Planning Commission Meeting Meeting

Planning Commission Meeting Agenda Report

TO: Jodie Steffes, Community Development Director
FROM: Beth Richmond, City Planner
SUBJECT: South 47 Retail Site Plan
DATE: July 15, 2026
APPLICANT: Classic Construction (Brian Larson)
LOCATION: 4201 Saint Francis Blvd NW (PIN 06-33-24-11-0083)
COMP PLAN: Commercial
ZONING: B-2 General Business

SITE PLAN

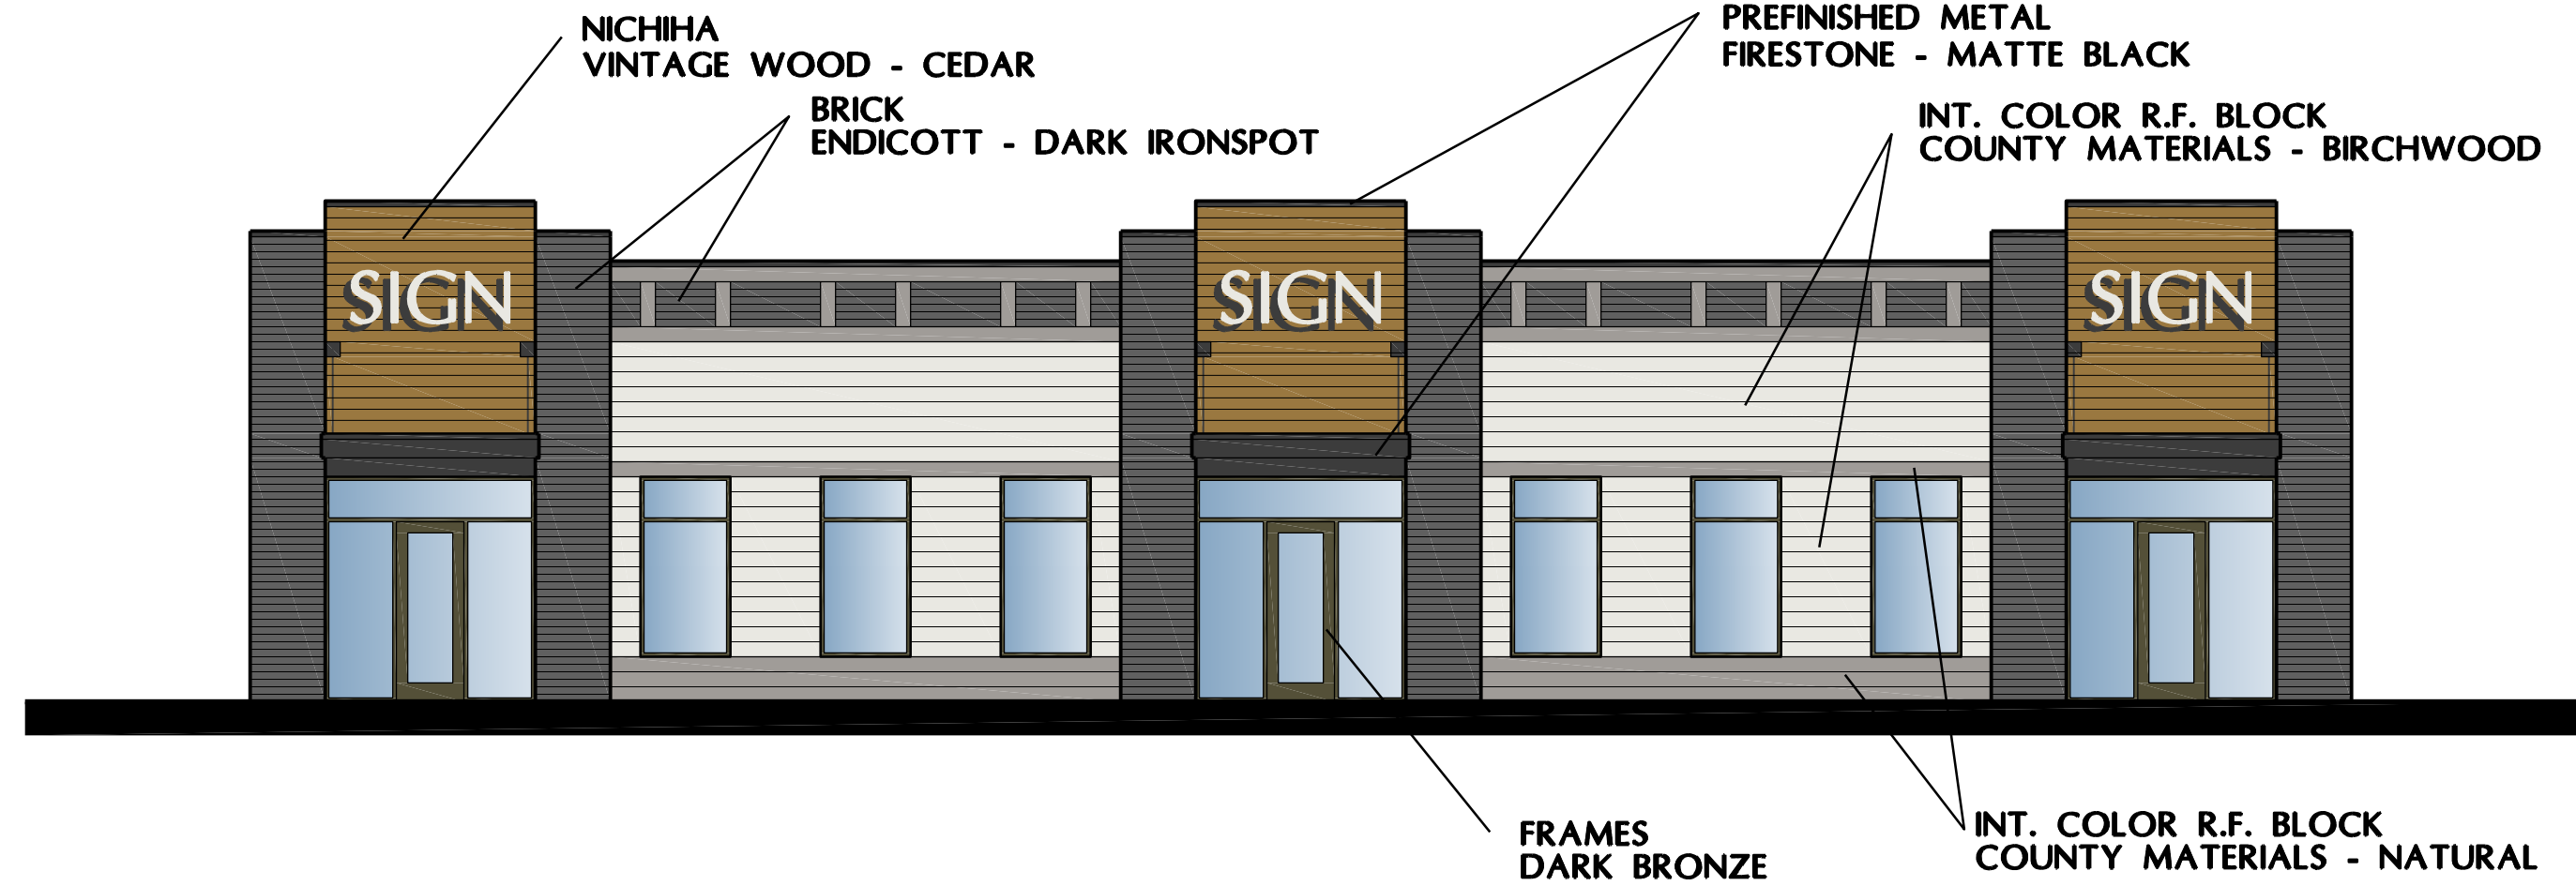
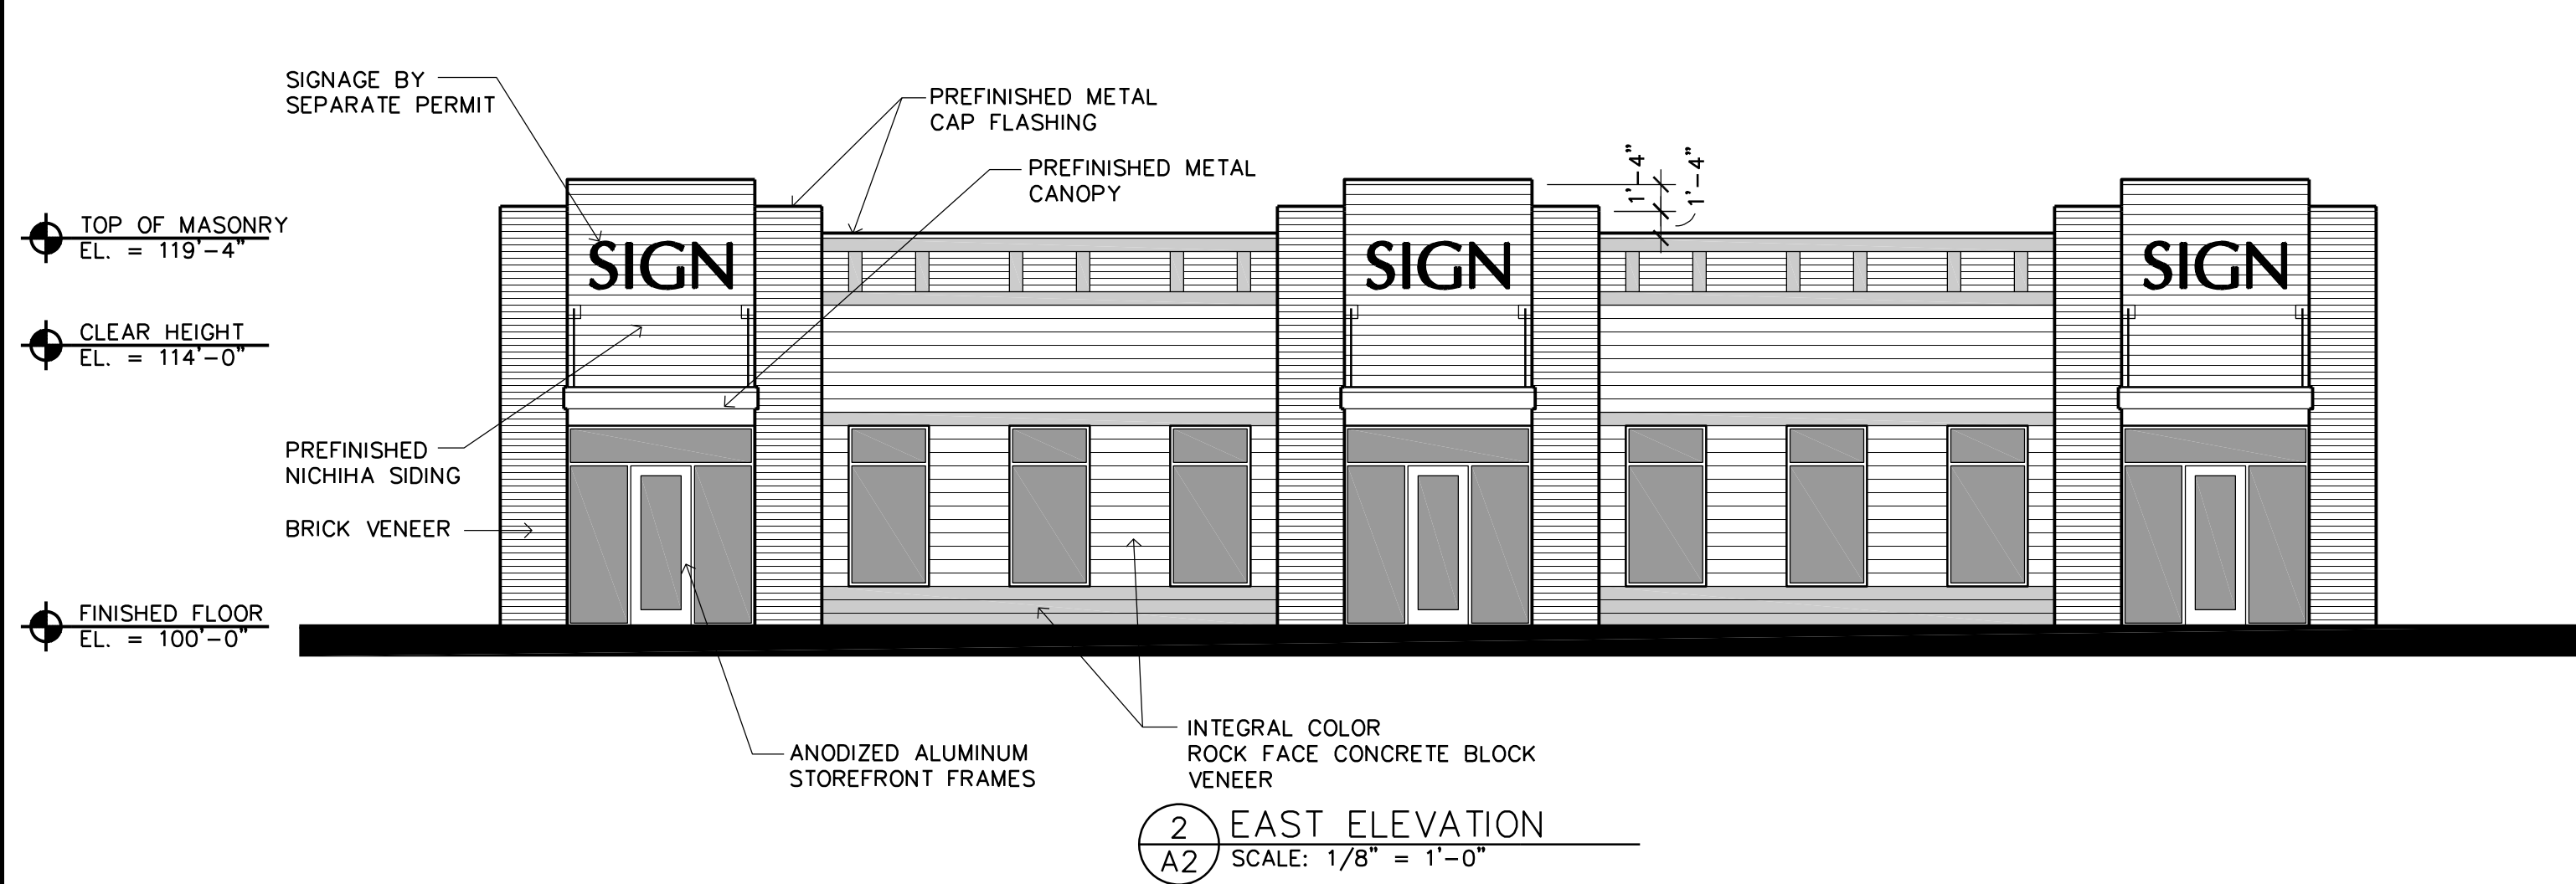
Staff has identified a discrepancy in the way that the setbacks have been labeled on the site plan. Based on the definitions below, the property lines should be labeled as follows:

Because of this discrepancy, the building has been proposed 18' from the west property line, which does not meet the rear setback requirement of 25'. The applicant will need to adjust the plans to meet the required setback.

City Code requires standalone retail parking to be provided at a rate of 1 space per 200 SF of floor area of retail space and 1 space per 500 SF of storage area. The applicant proposes a parking area with 29 stalls (28 provided and 1 proof of parking) located east of the building. The proposed parking area does not meet the minimum requirements for number of stalls, which calculates to 37 stalls. The applicant should update the plans to meet the minimum number of parking stalls.

1. The applicant shall revise the site plan to properly identify all setbacks and meet the minimum 25-foot rear setback requirement.
2. The front building wall (east side) shall be revised to ensure that 100% of the façade is made up of high-quality materials as listed in Code Section 10-71-08 Building Type and Construction, or the applicant must demonstrate that prefinished nichida

4. The applicant shall revise the site plan to meet the minimum number of parking spaces required by Code. Standalone retail parking must be provided at a rate of 1 space per 200 SF of floor area of retail space and 1 space per 500 SF of storage area, or 37 stalls.
